Minnehaha County Facilities & Construction

Energy Plant Chiller Replacement 415 N. Dakota Ave. Sioux Falls, SD 57104

ADDENDUM NO. 3:

DRAWING SHEETS M1

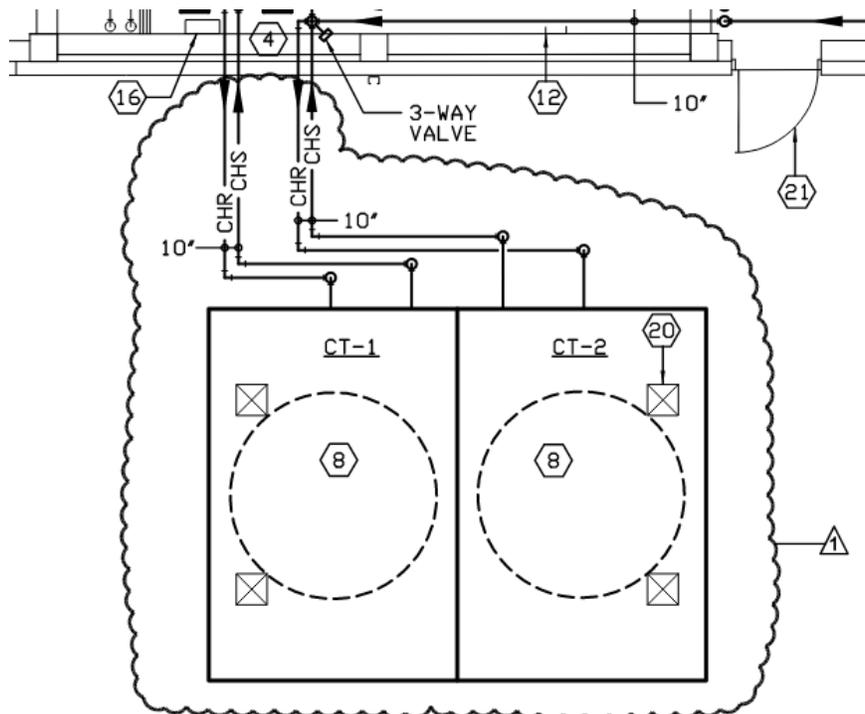
- 1. COOLING TOWER SCHEDULE: Replace the schedule with this schedule. The towers are completely independent but is a "twinned" style that can be co-located.

COOLING TOWER SCHEDULE															
CHILLER NO.	MANUF	MODEL NO.	TONS REJECTED	GPM	EWT	LWT	EADB	EAWB	CFM	ELEC. VOLT	PH	FAN HP	FLA	OPER. WEIGHT	REMARKS
CT-1	EVAPCO	AT 224-4P18	882.5	2125	94	84	95	78	164,350	480	3	60	68.3	22,520	ALL
CT-2	—	—	882.5	2125	94	84	95	78	164,350	480	3	60	68.3	22,520	ALL
REMARKS:															
1. INLET PRESSURE DROP 3 PSI. 17 GPM EVAP RATE. SOUND PRESSURE 84/71 dB(A) SIDES, 85/72 ENDS, 88/79 TOP @ 5'/50'.															
2. PROVIDE WITH TWO 15 KW TANK HEATERS AT EACH BASIN, 460V/3PH WITH INTEGRAL CONTROLS.															
3. CT-1 AND CT-2 ARE EACH ONE SIDE OF THE DOUBLE UNIT. SCHEDULE PERFORMANCE IS FOR EACH. TOWERS SHALL OPERATE COMPLETELY INDEPENDENTLY.
